### 3B Containment Hydrodynamic Loads

The information in this appendix of the reference ABWR DCD, including all subsections, tables, and figures, is incorporated by reference with the following departures.

STD DEP 3B-2 (Table 3B-1, Figures 3B-12 and 3B-13)

Figure 3B-12 Time History of Air Bubble Pressure

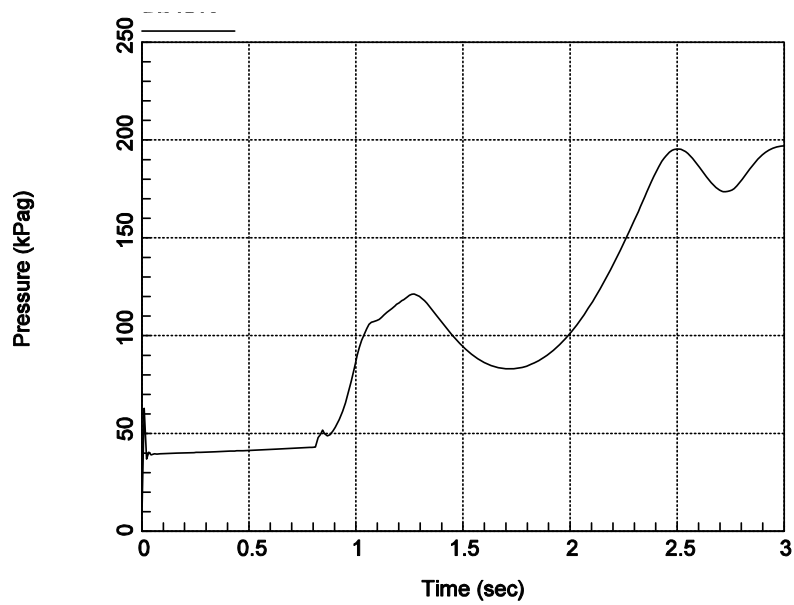
| Description                           | Value                                  |
|---------------------------------------|--|
| 1. Air bubble pressure (maximum)      | <del>133.37 kPaG</del> <b>195 kPaG</b> |

Figure 3B-13 Schematic of the Pool Swell Phenomenon

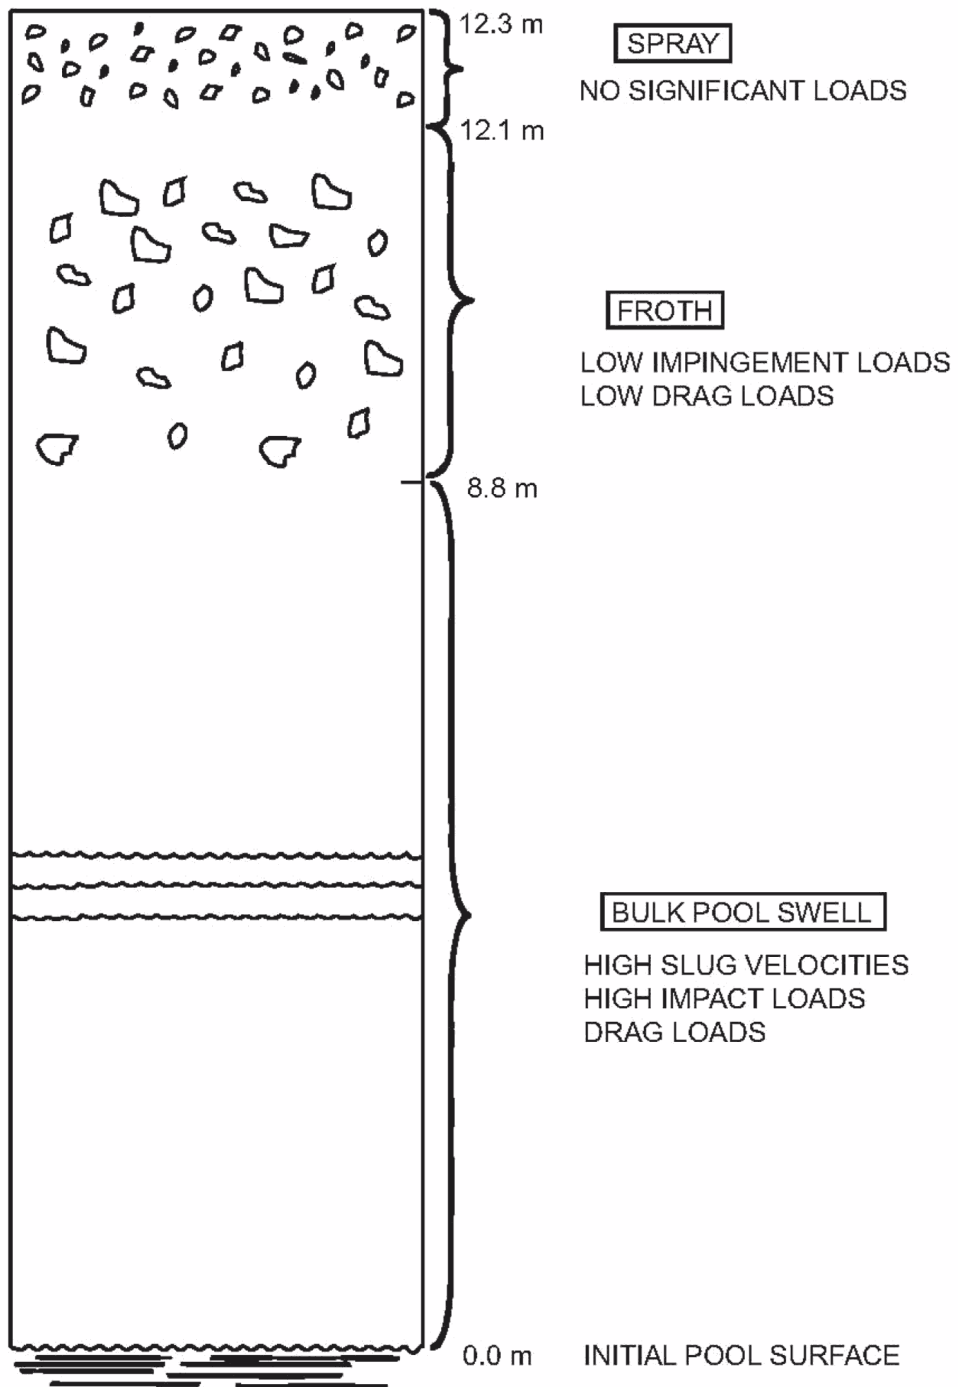
Structures located between 0 and ~~7m~~8.8m above the initial surface will be subjected to impact load by an intact water ligament, where the ~~7m~~8.8m value corresponds to the calculated maximum pool swell height. The load calculation methodology will be based on that approved for Mark II and Mark III containments (NUREG-0487 and NUREG-0978).

Structures located at elevations between the ~~7m~~8.8m and ~~40.3m~~12.1m will be subjected to froth impact loading. This is based on the assumption that bubble breakthrough (i.e., where the air bubbles penetrate the rising pool surface) occurs at ~~7m~~8.8m height, and the resulting froth swells to a height of 3.3m. ~~This froth swell height is the same as that defined for Mark III containment design and this.~~ This is considered to be conservative for the ABWR design. Because of substantially smaller wetwell gas space volume (about 1/5th of the Mark III design), the ABWR containment is expected to experience a froth swell height substantially lower than the Mark III design. The wetwell gas space is compressed by the rising liquid slug during pool swell, and the resulting increase in the wetwell gas space pressure will decelerate the liquid slug before the bubble break-through process begins. The load calculation methodology will be based on that approved for the Mark III containment (NUREG-0978).

As shown in Figure 3B-13 the gas space above the ~~40.3 m~~12.1m elevation will be exposed to spray condition ~~including~~ which is expected to induce no significant loads on structures in that region.

Figure 3B-21 ABWR CO Source Load Methodology

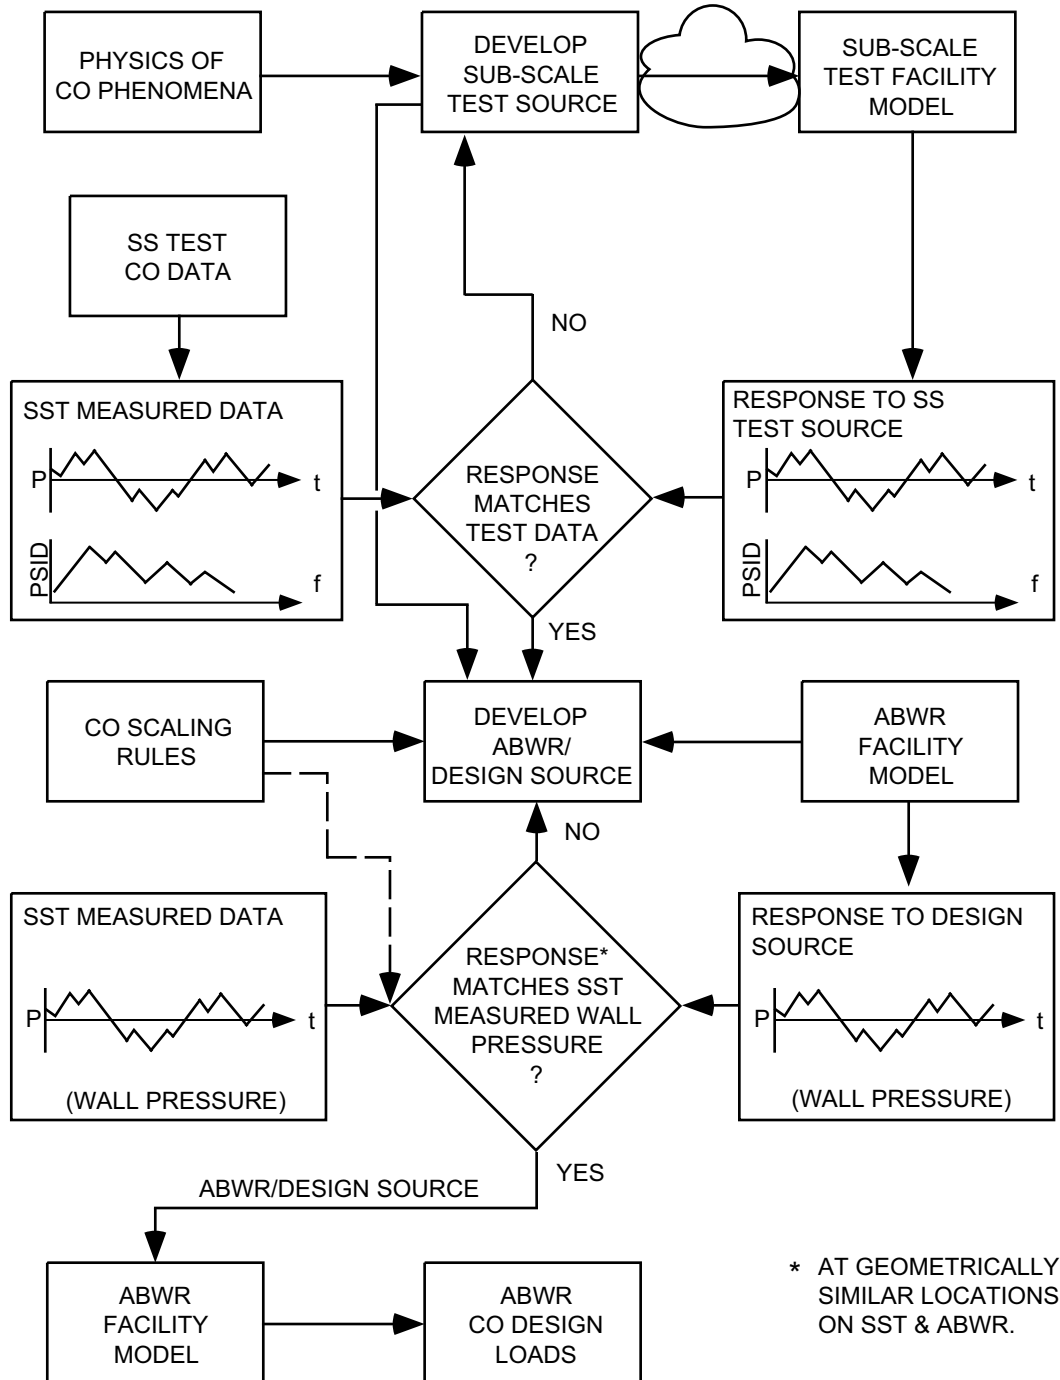
STD DEP Admin (Figures , 3B-21, 3B-24, 3B-26)
